Re: McGuire Nuclear Station
Units 1 and 2
Docket Nos. 50-369, -370

McGuire Nuclear Station

Response to NRC Request for Additional Information "Potential Over-Pressurization of Containment in the Event of MSLB."

FLOW DIAGRAM OF AUXILIARY
FEEDWATER

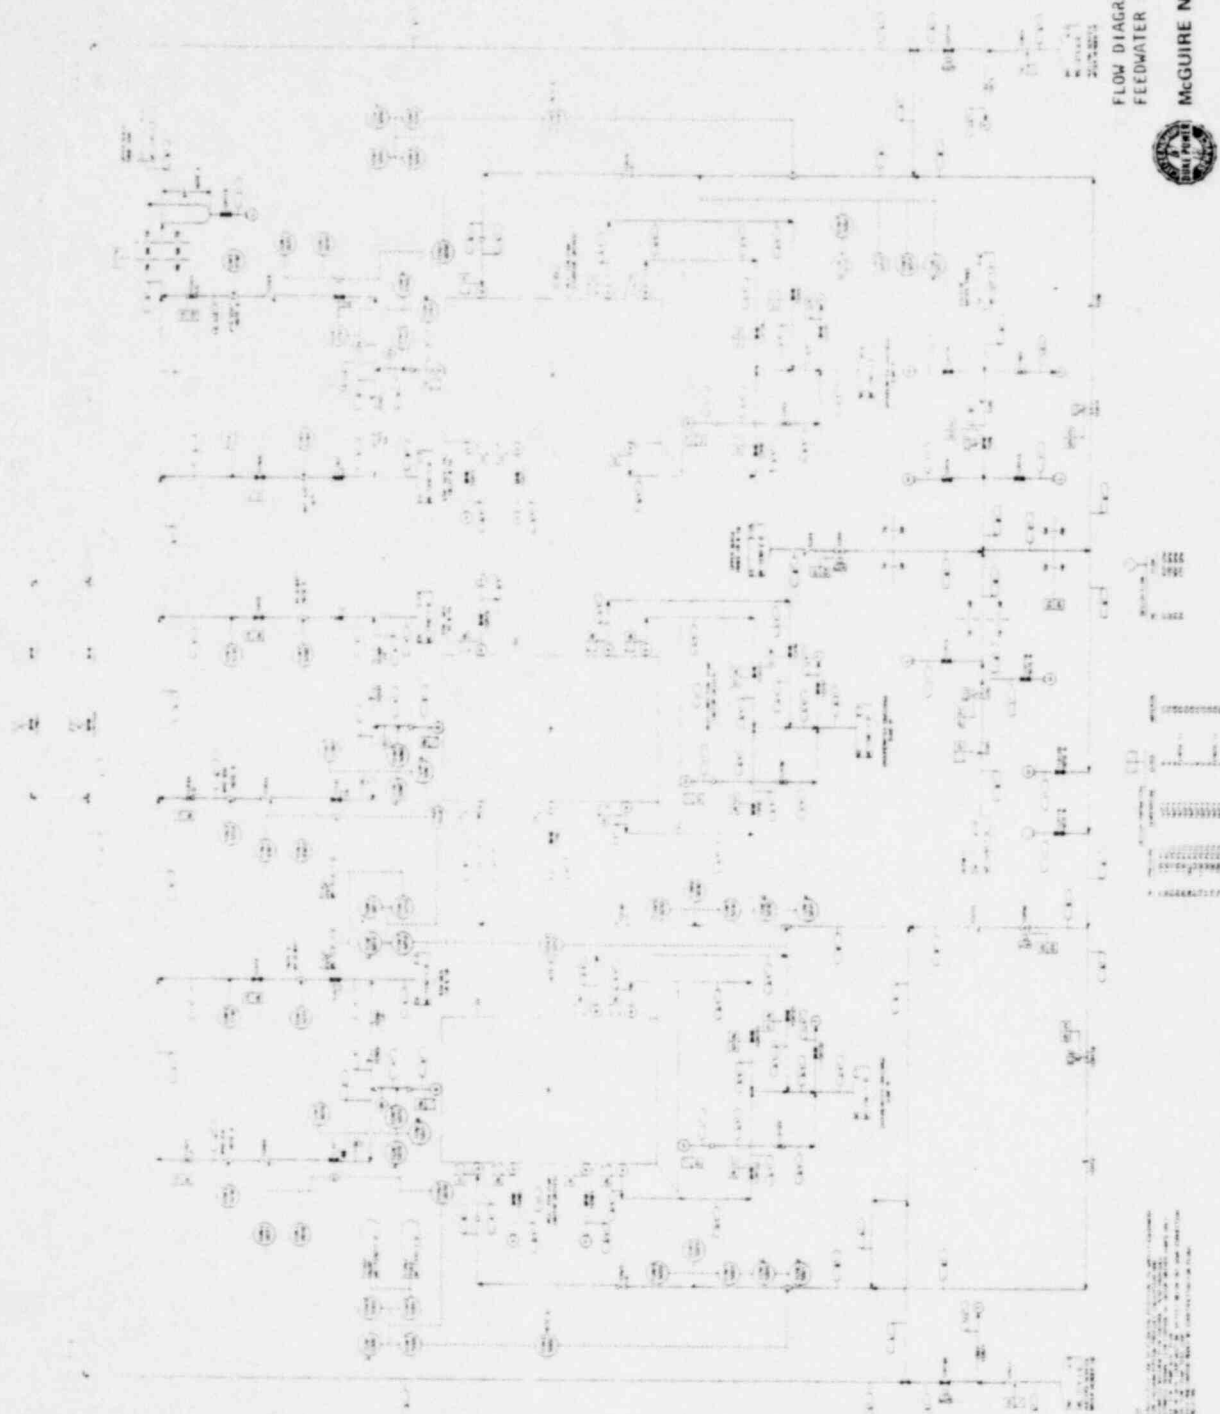
- c. See attached flow diagrams for system configuration.
- d. The auxiliary feedwater system will be actuated shortly after the occurrence of a steamline break. In the analysis the auxiliary feedwater flow to the faulted steam generator was assumed to exist from the time of the rupture until realignment of the system is complete. The auxiliary feed-

Flow is controlled by throttle valve travel stops set to allow the turbine driven pump to supply 150 gpm to each of three intact steam generators with approximately 330 gpm supplied to the faulted generator. The turbine driven pump therefore supplies the required 450 gpm ($3 \times 150 = 450$) to three intact steam generators.

Throttle valve travel stops on each motor driven pump are set to limit flow to two intact steam generators 50 170 gpm each. This throttle position limits flow to the faulted steam generator to 380 gpm allowing 110 to be fed to the intact steam generator. Together the motor driven pumps supply the required 450 gpm ($2 \times 170 + 110 = 450$) to three intact steam generators with 380 gpm lost to the faulted steam generator.

The travel stops on the throttle valves limit pump runout to approximately 675 gpm for each motor driven pump and approximately 1100 gpm for the turbine driven pump assuming complete depressurization of all steam generators.
